Dom area and Leichhof development | Mainz 1250

25.03.2019 | screenshots of the model (starting material)

21.04.2020 | Guido Faccani

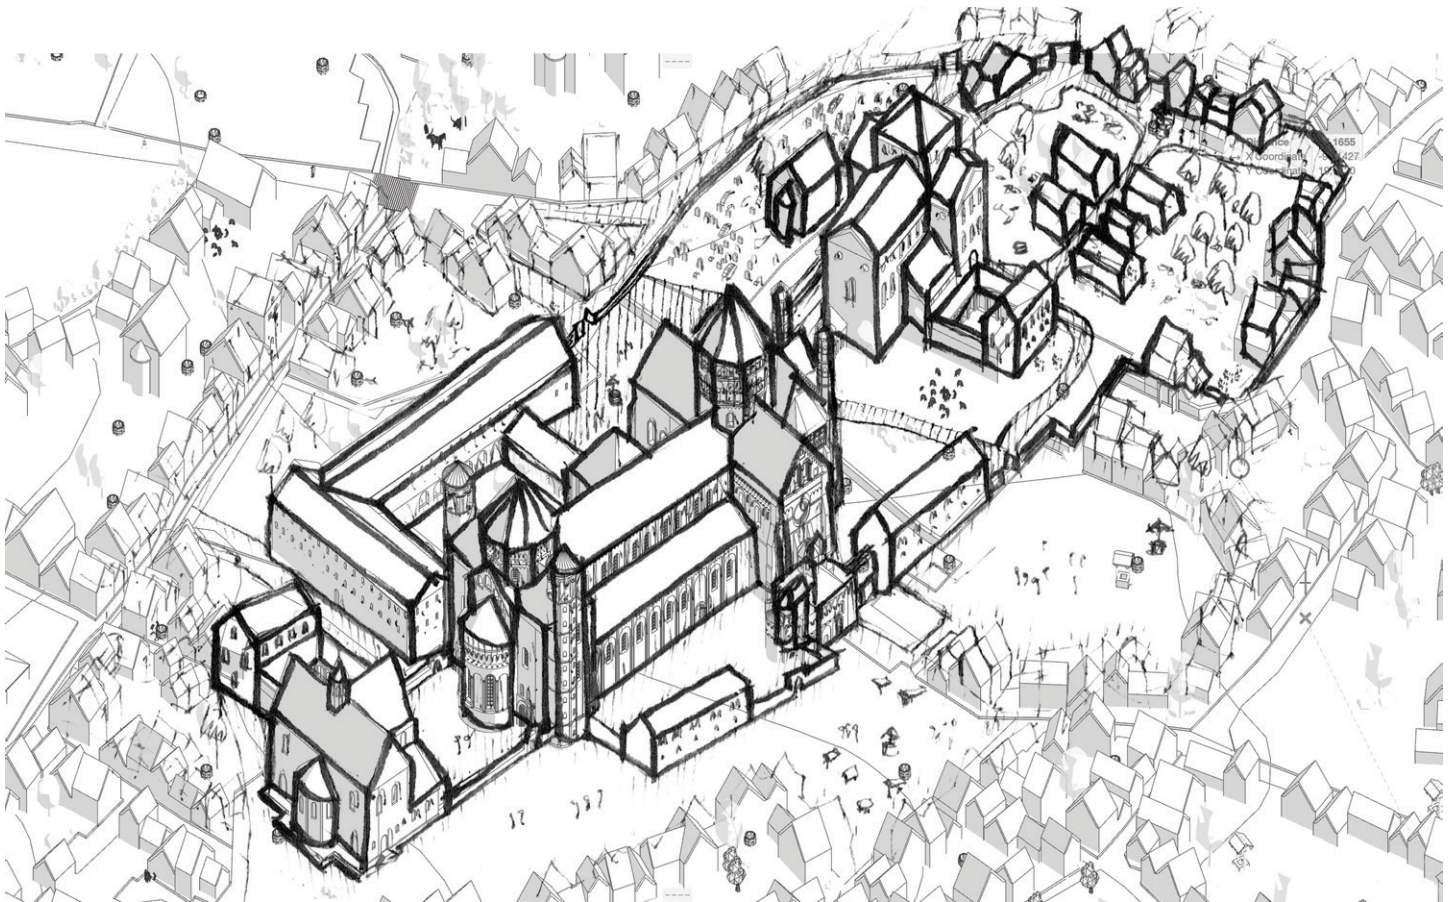
magenta Skizze richtig
verstanden haben.

Turm Spitze Höhe?

Traufhöhe ?

Traufhöhe ?

Mr. Faccani advice us not to stress the way.
The »Paradies« was indeed a curtain.
It is better to sugesst here just a free space,
and not to draw (and model a street)

In unserer Rekonstruktion um 1250 haben wir ein
verkürztes Seitenschiff im vgl. zu 800.

Infolge hätten wir nun (wenn wir die Struktur des
s von 800 weiter
denken) hier eine Lücke (blau markiert).

Mainz 1250

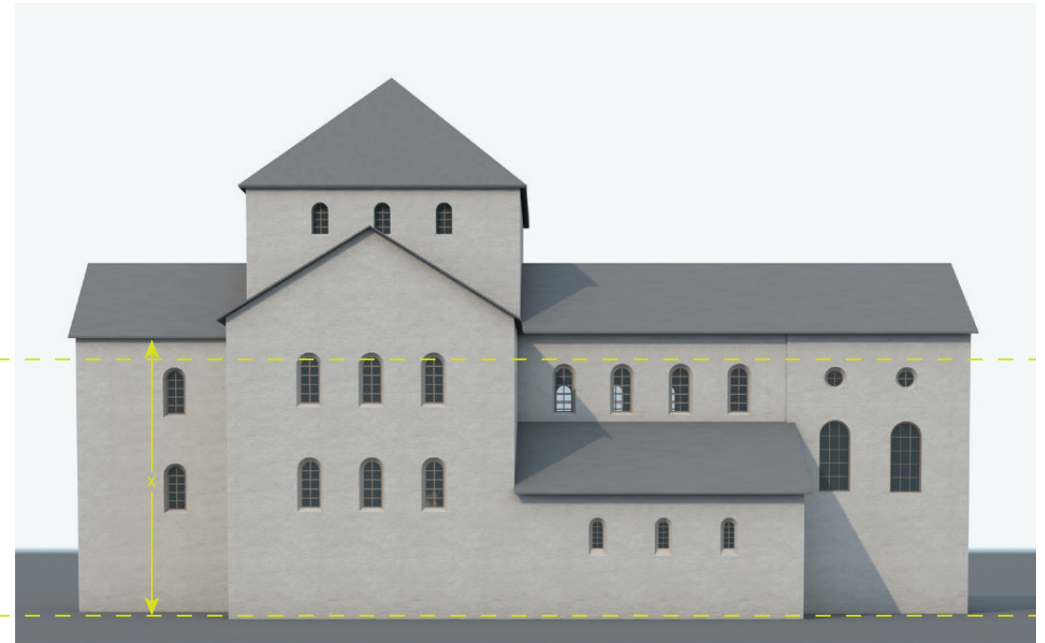
The x dimension is now 22.75 m in Mainz 1250.
According to the orally transferred information,
it should have 14 m.
